## **ADDENDUM NO. 3**

Date: April 1, 2019

**Project:** 0490-416, Sutter Structural Repairs

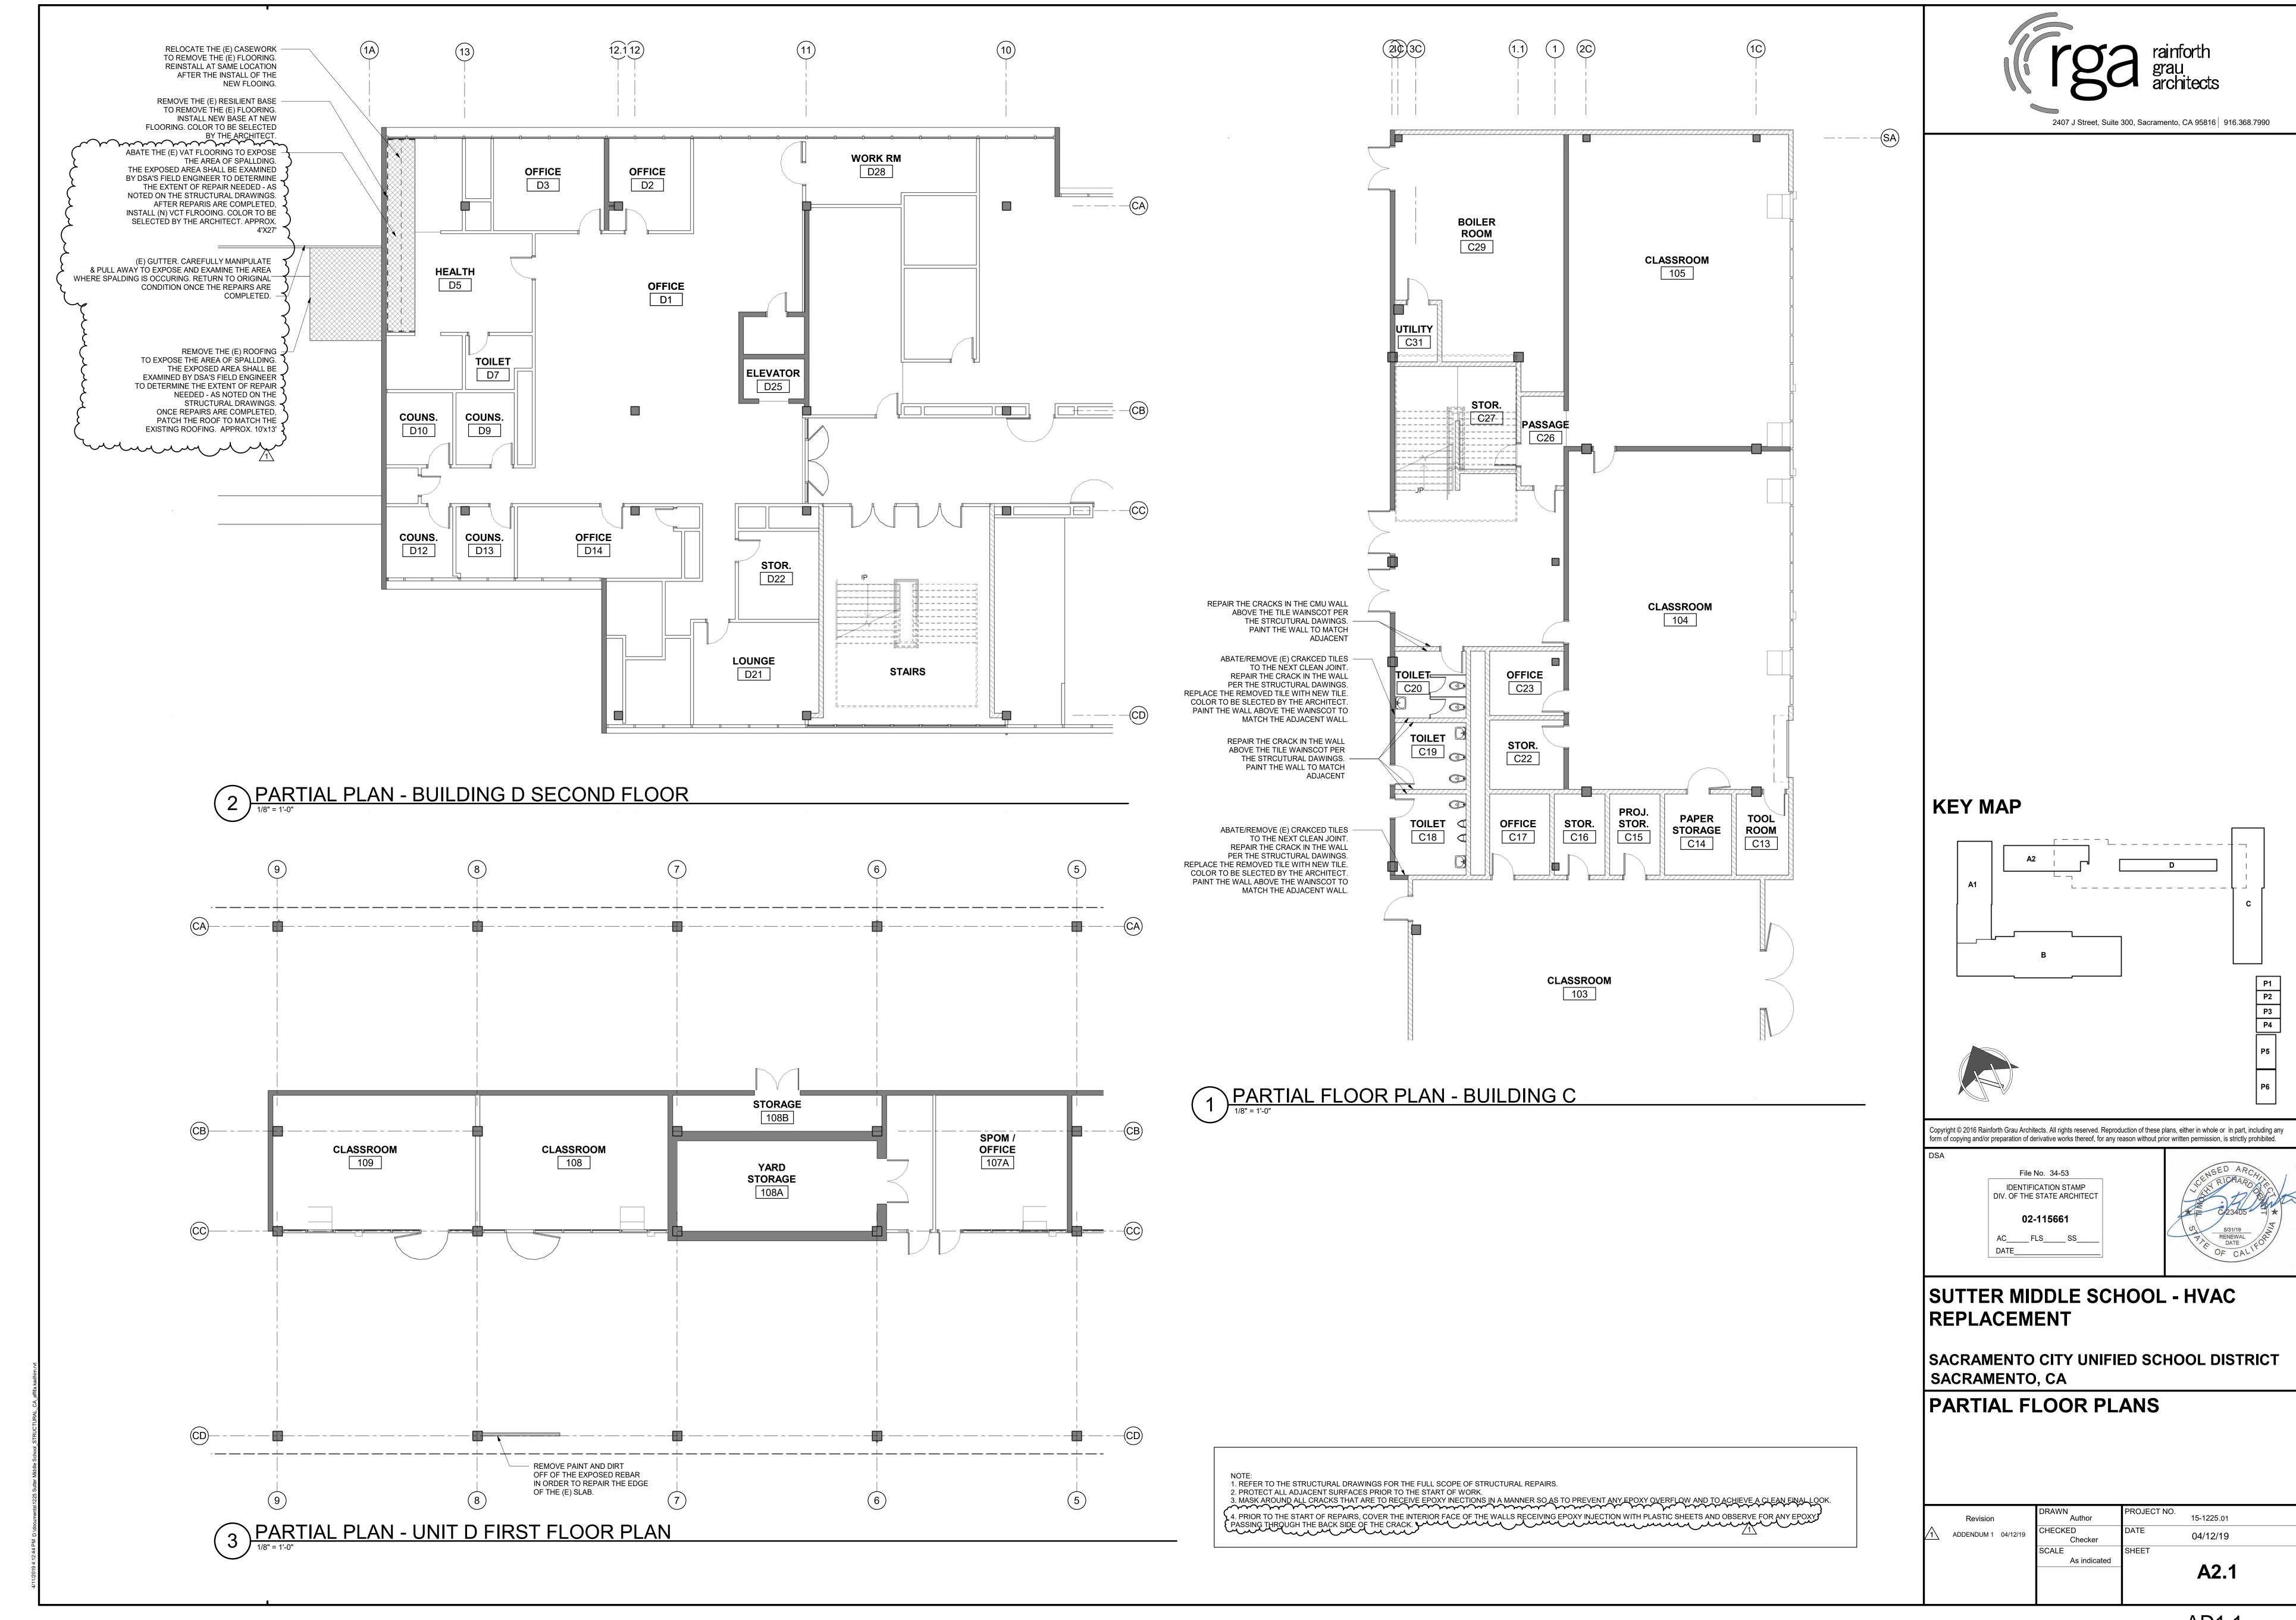
- A. Sheet A2.1, Partial Floor Plans
  - 1. DELETE this sheet in its entirety and REPLACE with drawing AD1.1 included with this addendum.
- B. Sheet AS1.1.0, General Notes
  - 1. DELETE this sheet in its entirety and REPLACE with drawing AD1.2 included with this addendum.
- C. Sheet S1.1.1, Repair Details

- 1. DELETE this sheet in its entirety and REPLACE with drawing AD1.3 included with this addendum.
- D. Sheet S2.1.0, Repair Floor Plan Units A1/B
  - 1. DELETE this sheet in its entirety and REPLACE with drawing AD1.2 included with this addendum.
- E. Sheet S2.1.1, Repair Floor Plan Units C &D
  - 1. DELETE this sheet in its entirety and REPLACE with drawing AD1.5 included with this addendum.
